PLANNING AMENDMENTS

**TWICKENHAM STADIUM
 EAST STAND EXTENSION**

LEVEL 4 PROPOSED GA PLAN

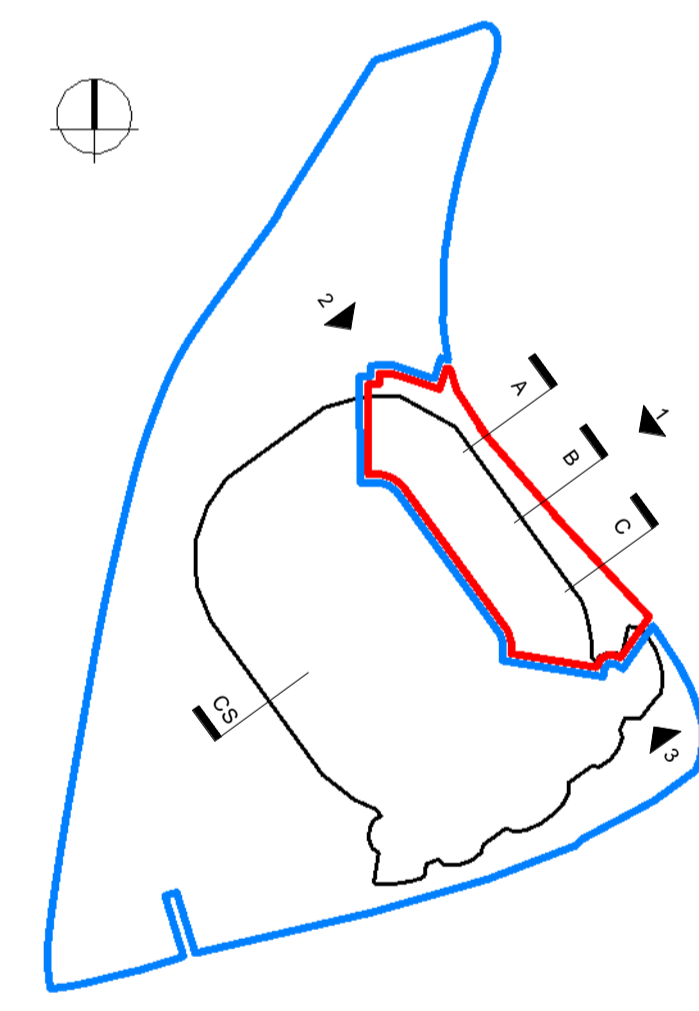
- A GENERAL AMENDMENTS TO THE SOUTH END.
- A1 INCREASED SHINGLES CLADDING AREA AND CURTAIN WALL REDUCED ACCORDINGLY.
- A2 REDUCED MASSING AND REVISED INTERFACE WITH THE SOUTH STAND.

- B PPC LOUVRES LOCATED TO THE BOWL SIDE HAVE BEEN OMITTED.
- C CURTAIN WALL SETTING OUT REVISED GENERALLY. SILICONE JOINTS TO TRANSOMS AND MULLION REPLACED WITH CAPPED SYSTEM. LEVEL 04 PPC LOUVRES SETTING OUT & HEIGHT REVISED. MONORAIL FOR ABSEILING REMOVED.

- D GENERAL AMENDMENTS TO THE CENTRAL ELEVATION CANOPY AT LEVEL 5A REVISED GENERALLY AND STANDING SEAM REPLACED WITH SINGLE PLY MEMBRANE. SUPPORT COLUMNS TO ROOF CANOPY REVISED. SQUARE FASCIA TO ROOF EDGE.

- D1 LEVEL 5A GLAZED SCREEN EXTENDED IN HEIGHT AND PPC LOUVRES INCLUDED AT LOW LEVEL.
- D2 INCREASED SHINGLES CLADDING AREA AND CURTAIN WALL AREA REDUCED ACCORDINGLY. FOUR VERTICAL FINIS REMOVED.

- D3 PORCELAIN PANELS WITH SLOTTED HOLES FOR VENTILATION REPLACED WITH PPC LOUVRES. EXPRESSED HORIZONTAL PATTERN TO PORCELAIN PANELS OMITTED.
- E GENERAL AMENDMENTS TO THE NORTH END

- E1 PORCELAIN CLADDING REPLACED WITH PPC ALUMINIUM CLADDING.
- E2 GREEN WALL TO THE NORTH END EXTENDED AND PPC LOUVRES REMOVED.
- E3 INCREASED SHINGLES CLADDING AREA AND CURTAIN WALL REDUCED ACCORDINGLY.

- F FENCELINE, GATE AND PERIMETER COLUMNS SETTING OUT REVISED.
- G CANOPY TO TURNSTILES REVISED.
- F1 PORCELAIN PATTERN CHANGED FROM HORIZONTAL TO VERTICAL.

- H PORCELAIN PANELS TO THE SOFFIT OF THE ARCH REPLACED WITH PPC ALUMINIUM PANELS. PORCELAIN PANELS SETTING OUT REVISED.
- K ROOF TO LEVEL 5A (NORTH END) EXTENDED.

- L GLAZED SPANDREL PANELS REPLACED WITH METAL SPANDREL PANEL. PORCELAIN PANELS REPLACED WITH PPC ALUMINIUM CLADDING.
- L1 PPC LOUVRES INCLUDED FOR MECHANICAL VENTILATION.
